October 29, 2019
BOARD OF COUNTY COMMISSIONERS
ORANGE COUNTY, FLORIDA
Y20-719-TA / ADDENDUM # 3
EASTERN REGIONAL WATER SUPPLY FACILITY - SODIUM HYPOCHLORITE
SYSTEM CONVERSION TO BULK

REVISED Bid Opening Date: ~~November 5, 2019~~ November 7, 2019

TITLE LOW SIDE PARAPET WALL
FLASHING AT BLDG 50, 80 &
90

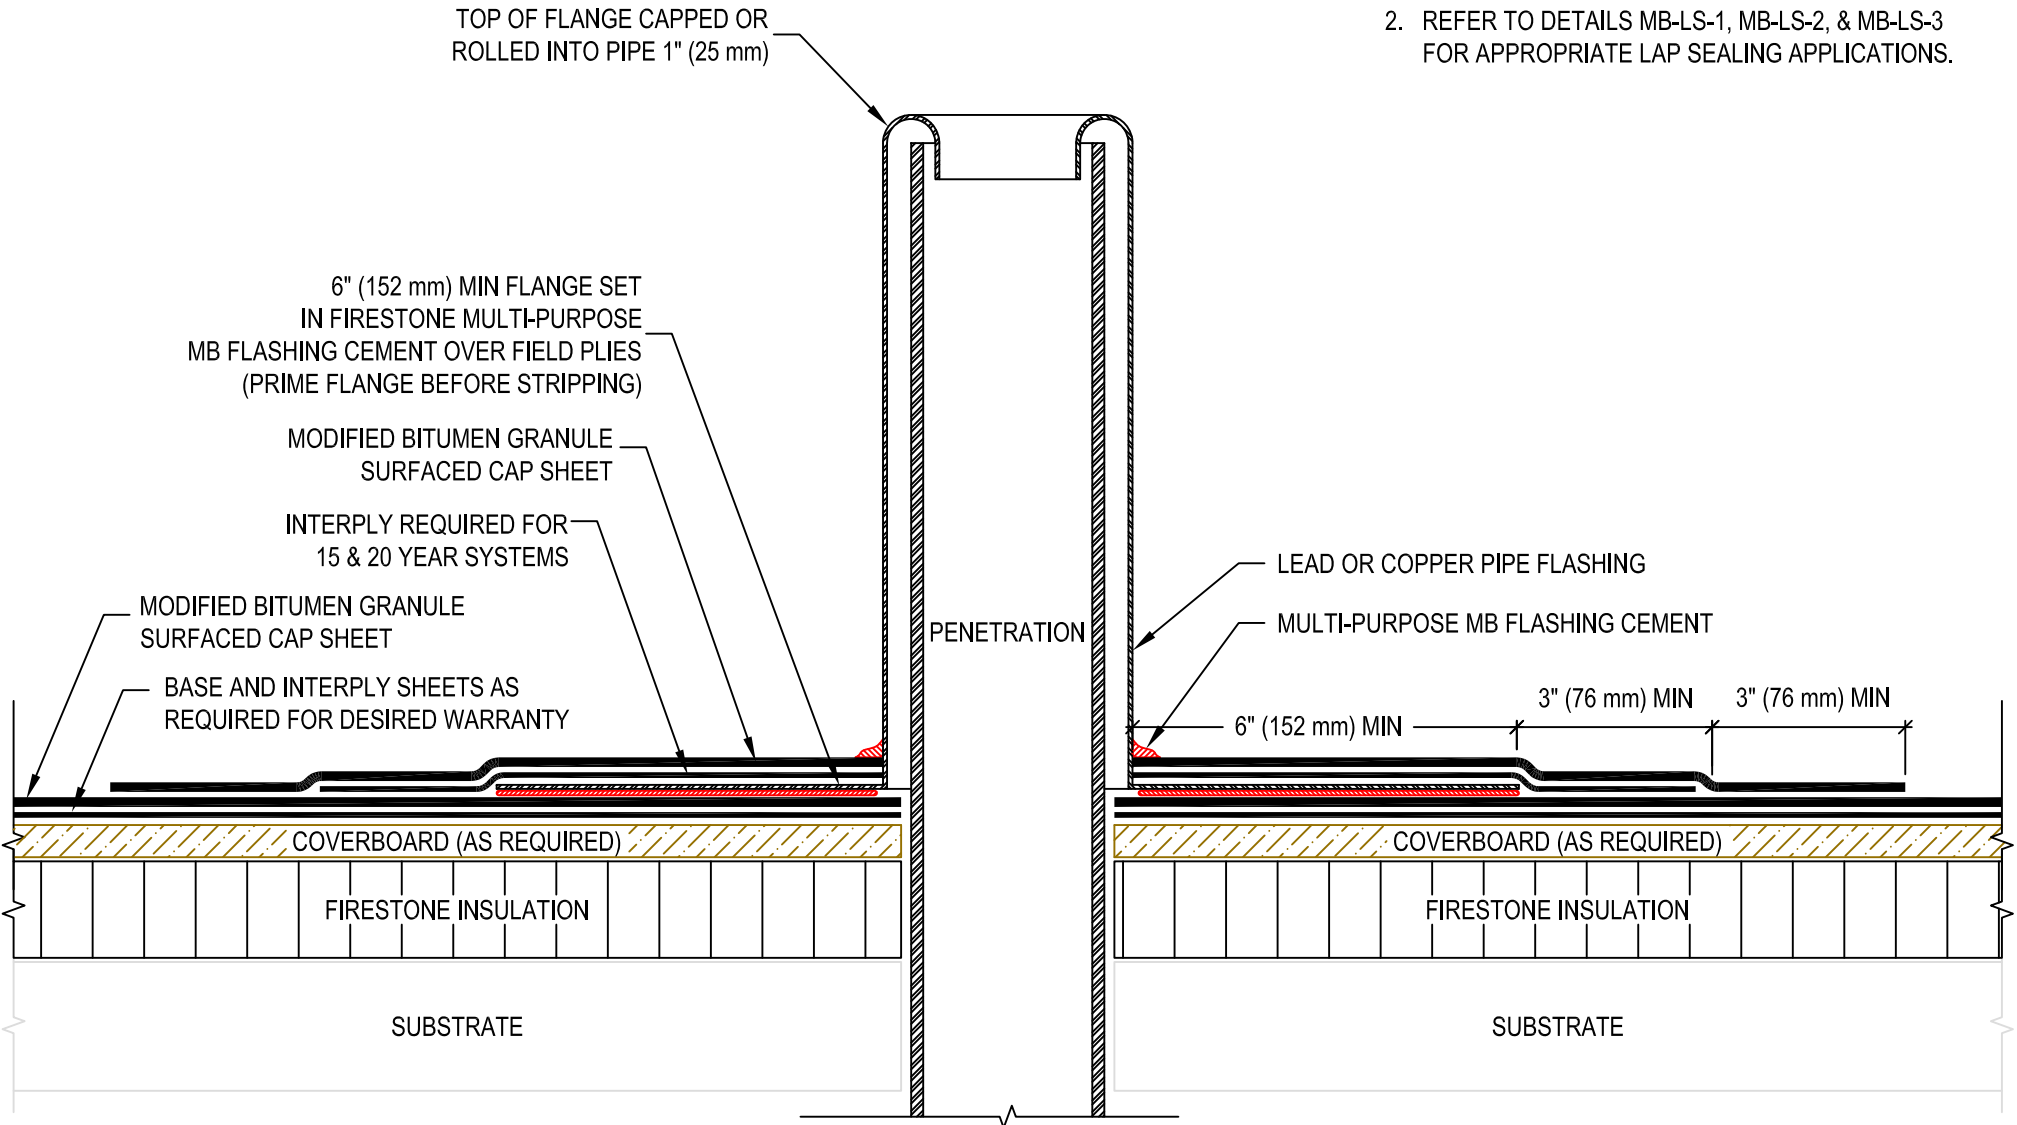
1. Q: What is the roofing material on building 50? Once the HVAC penetrations are made, what roofing repairs will need to be made?

A: See attached design development document (June 8, 2002) for description of the Building 50 roof membrane and associated detail No. 1.01. Any roofing membrane thru-penetrations or repair work necessary shall be watertight and in accordance with existing 20-year ND (No Dollar Limit) manufacturer's written weathertightness warranty provided by the Owner. Also attached is a typical penetration detail for membrane roofing that can be used as the basis of design. Actual thru-penetration and repair shall be approved by the roof manufacturer.

M101

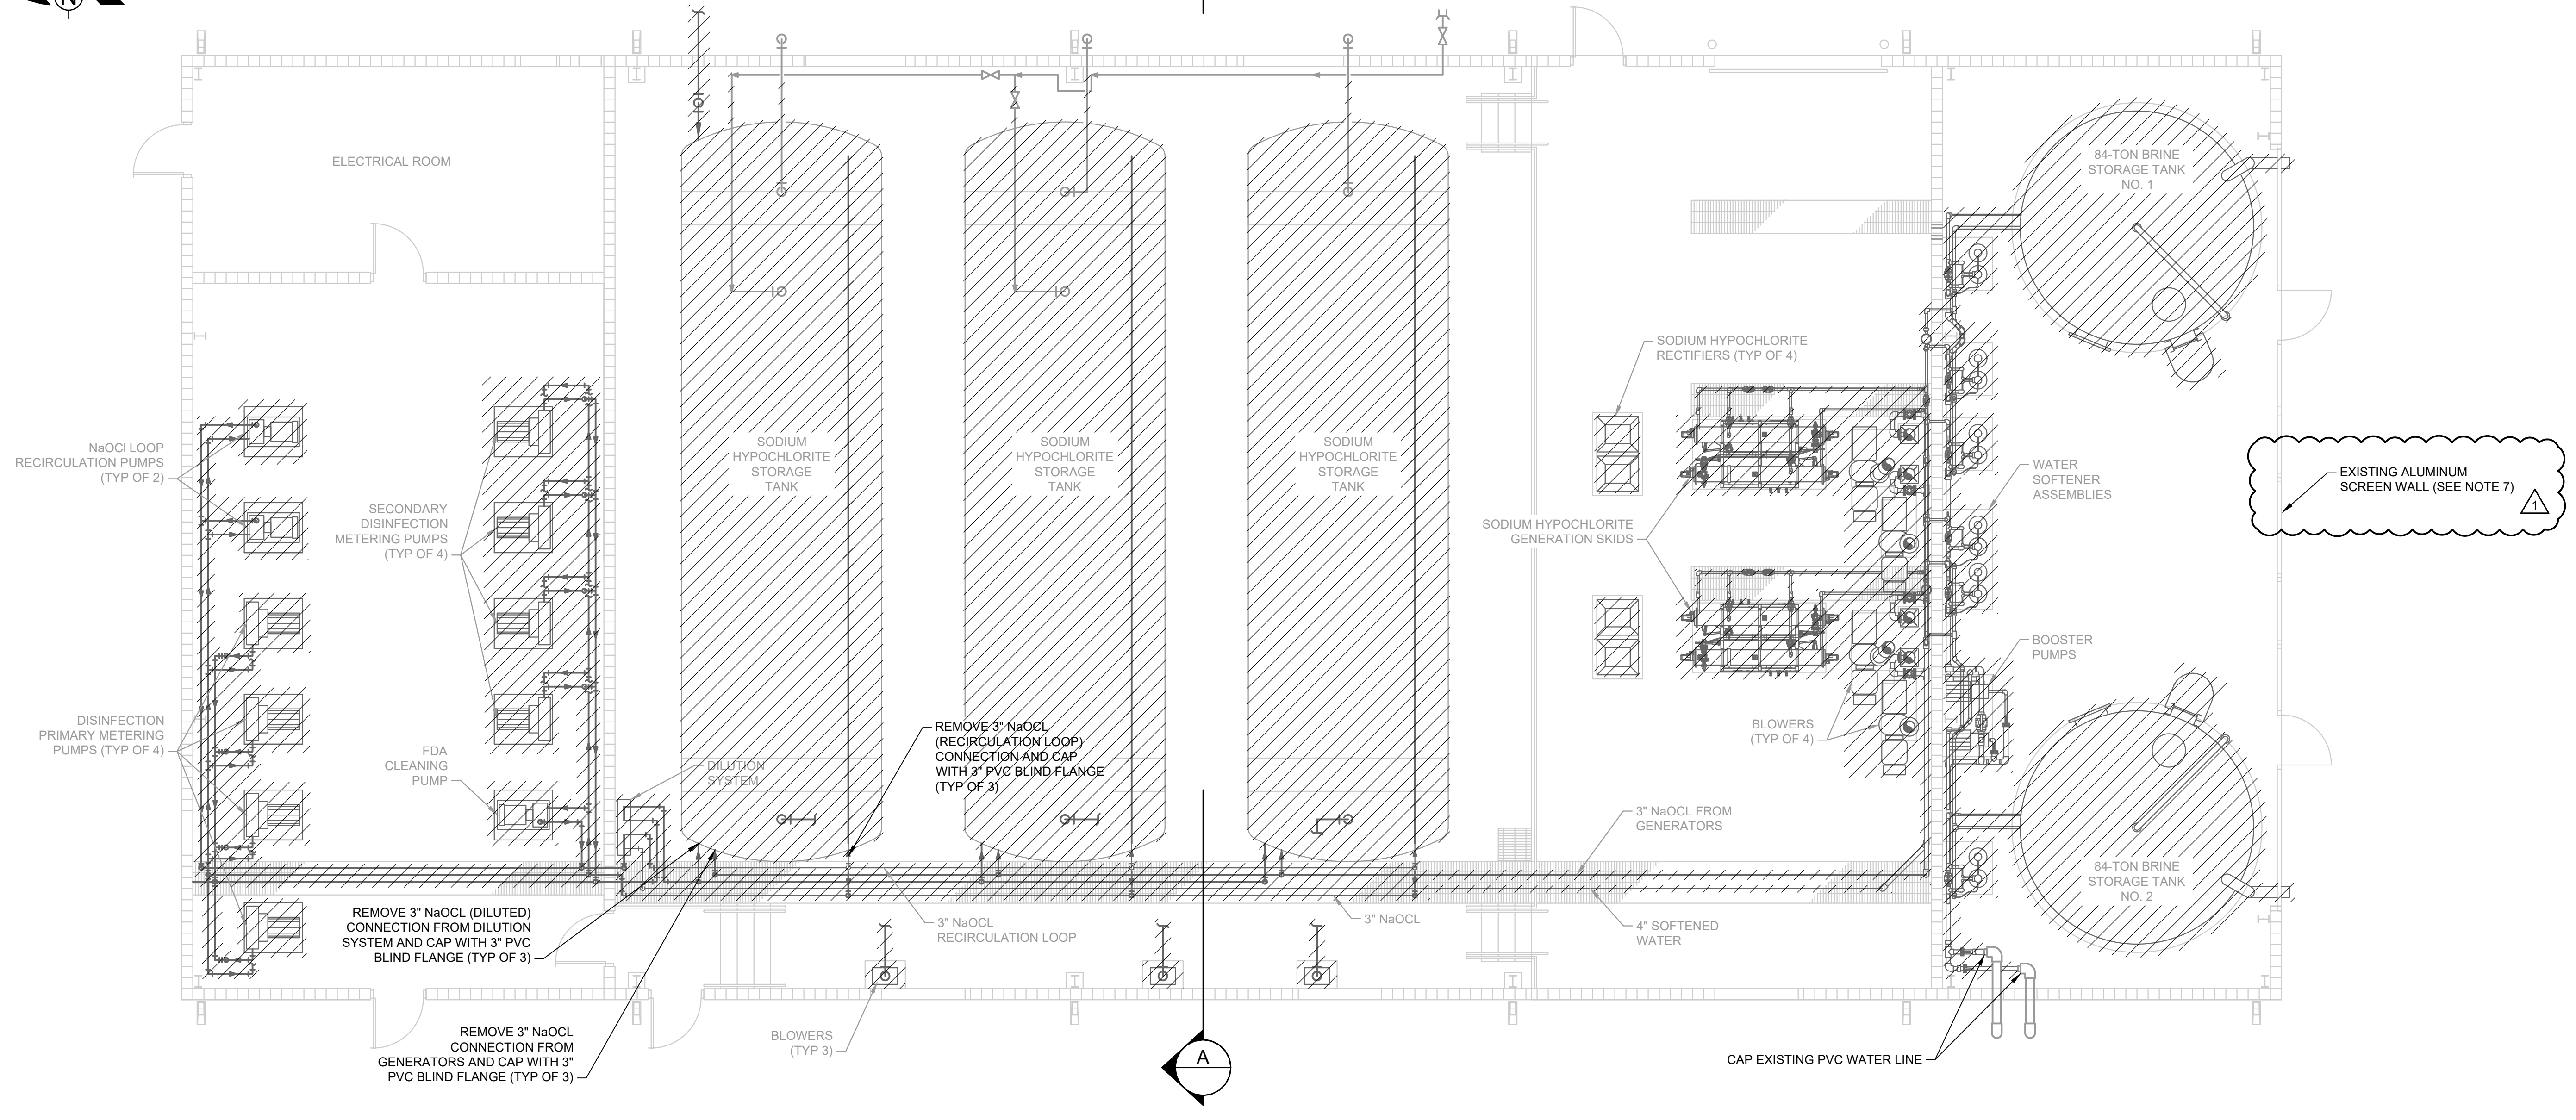
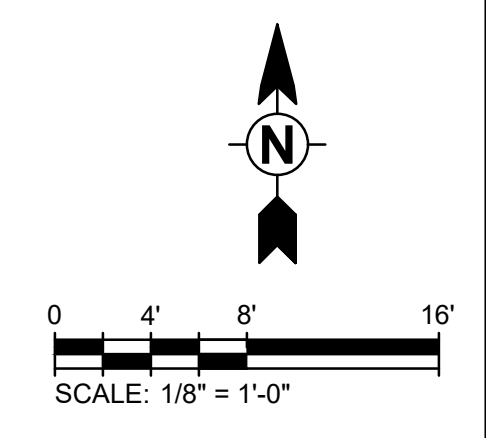
6. **Q: Sheet M101 call to remove existing Louvers at northside of Process 50 but after site visit, there is a rolling door at the east opening, please clarify if only the west opening should be demo' d and new coil door installed.**

A: Confirmed. Refer to S101, S102 and A101 for louver removal and overhead door installation. Refer to modifications below in Part C of this addendum.

- REMOVE EXISTING DUCTWORK INCLUDING ALL ASSOCIATED HANGERS, SUPPORTS, ETC.
- EXISTING LOUVER SHALL BE REMOVED AND REPLACED WITH ROLL UP DOOR. SEE ARCHITECTURAL/STRUCTURAL DRAWINGS FOR DETAILS.

D110

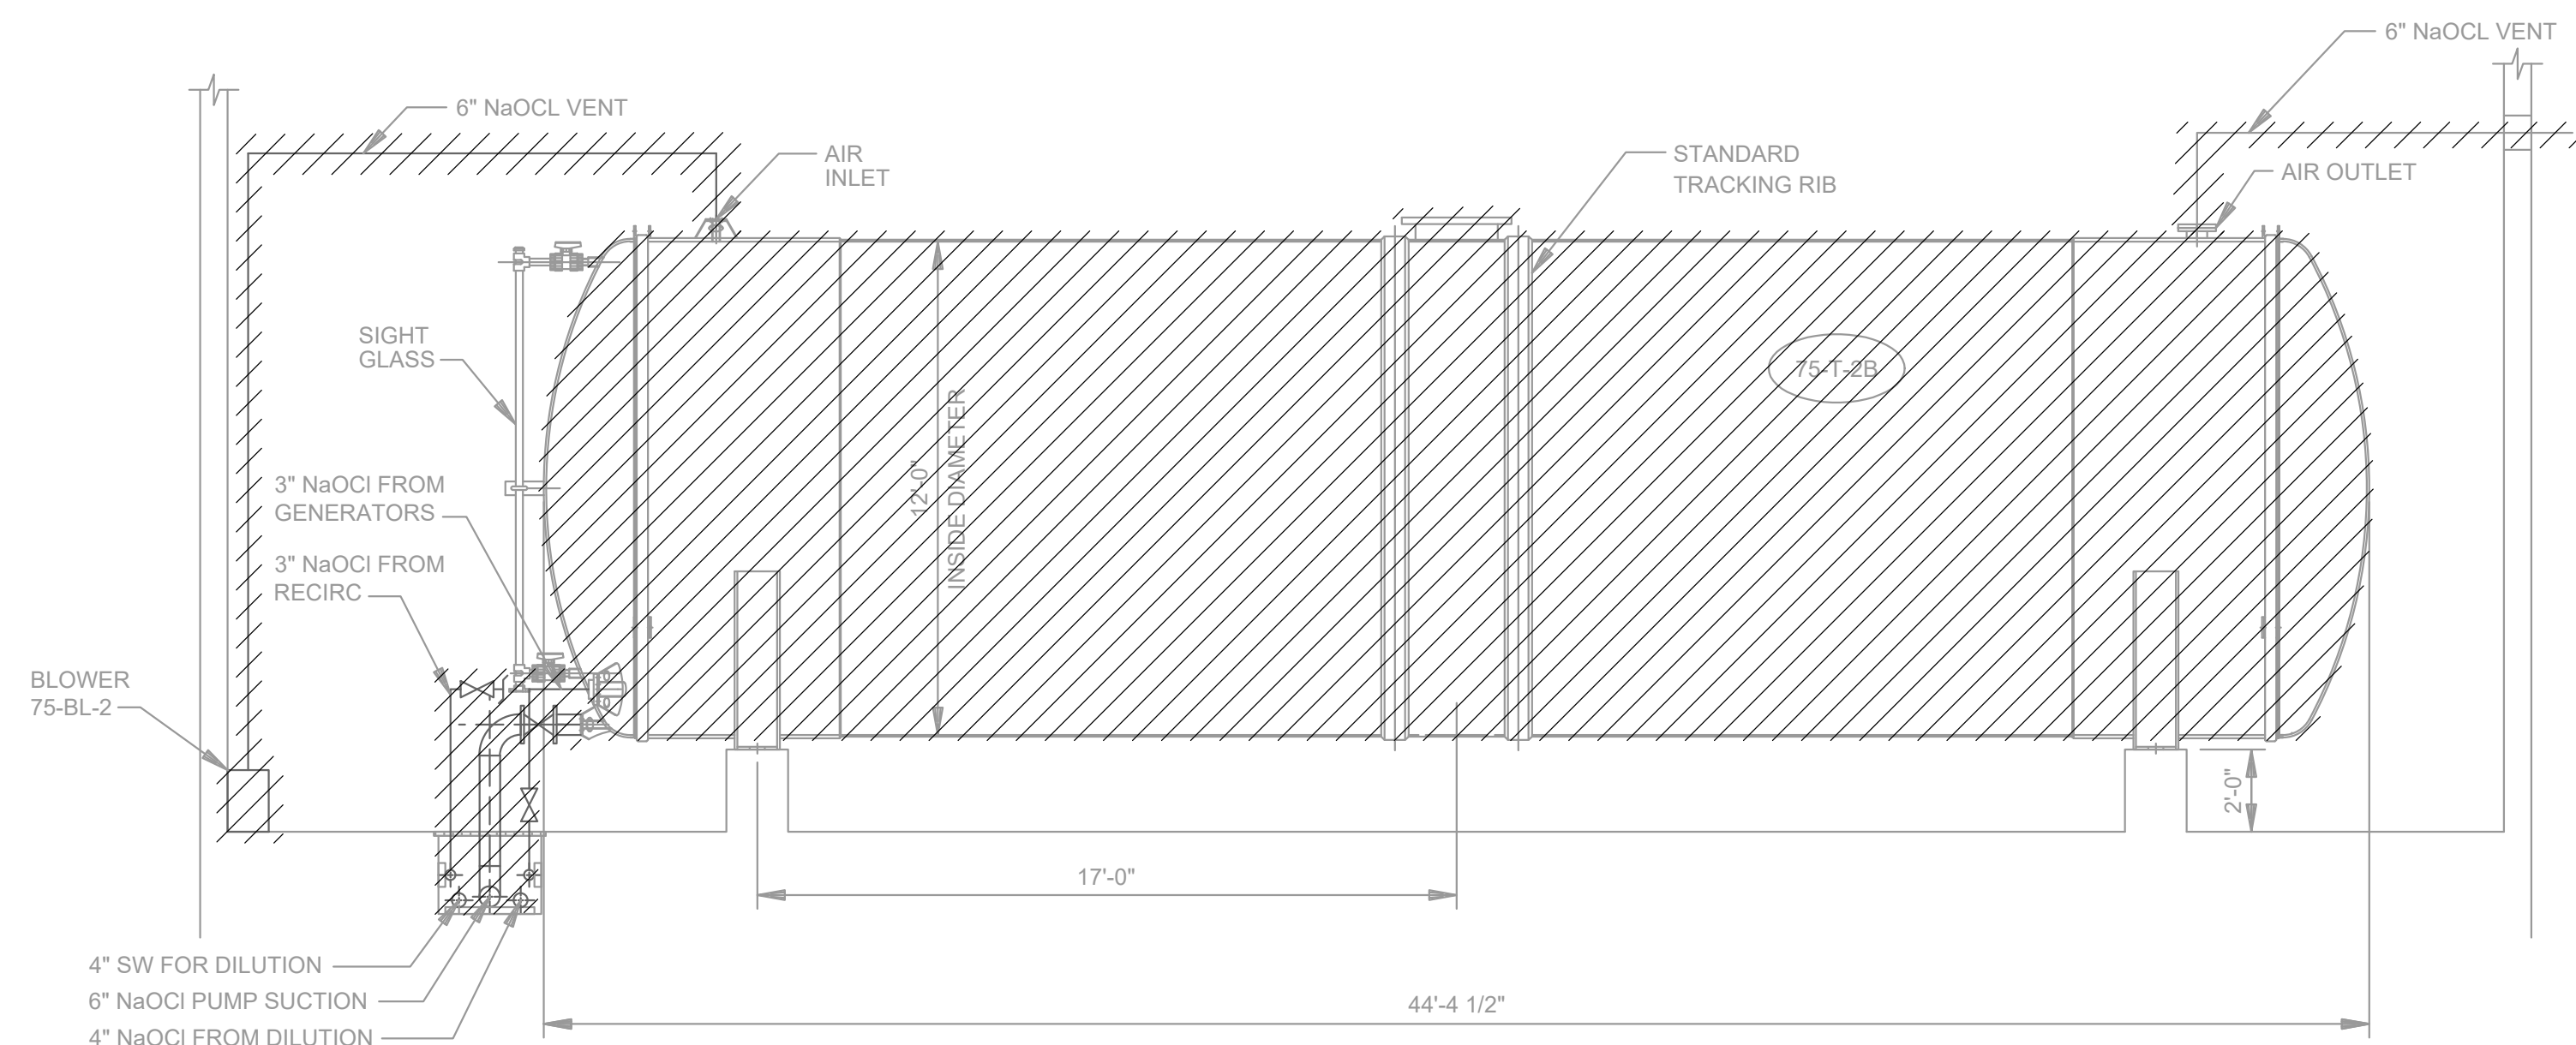
7. **Q: There is a screen wall at the Brine room in Process 75, as the contractor is to remove and replace the FRP tanks, the screen wall will need to be removed. Should the contractor re-install the existing or replace with new frame & screen?**

A: Replace any screen wall removed for removal of the brine storage tank and equipment in the brine room in Process Building 75 with new frame and screen. Refer to Drawing modifications below in Part B of this addendum.

- SEE SPECIFICATION SECTION 02050 FOR ADDITIONAL DEMOLITION REQUIREMENTS.
 - REMOVE AND REPLACE EXISTING ALUMINUM SCREEN WALL AS NEEDED TO REMOVE EXISTING BRINE STORAGE TANKS. ANY SCREEN / ALUMINUM FRAME REMOVED FOR ACCESS TO BRINE STORAGE TANKS SHALL BE REPLACED WITH NEW.
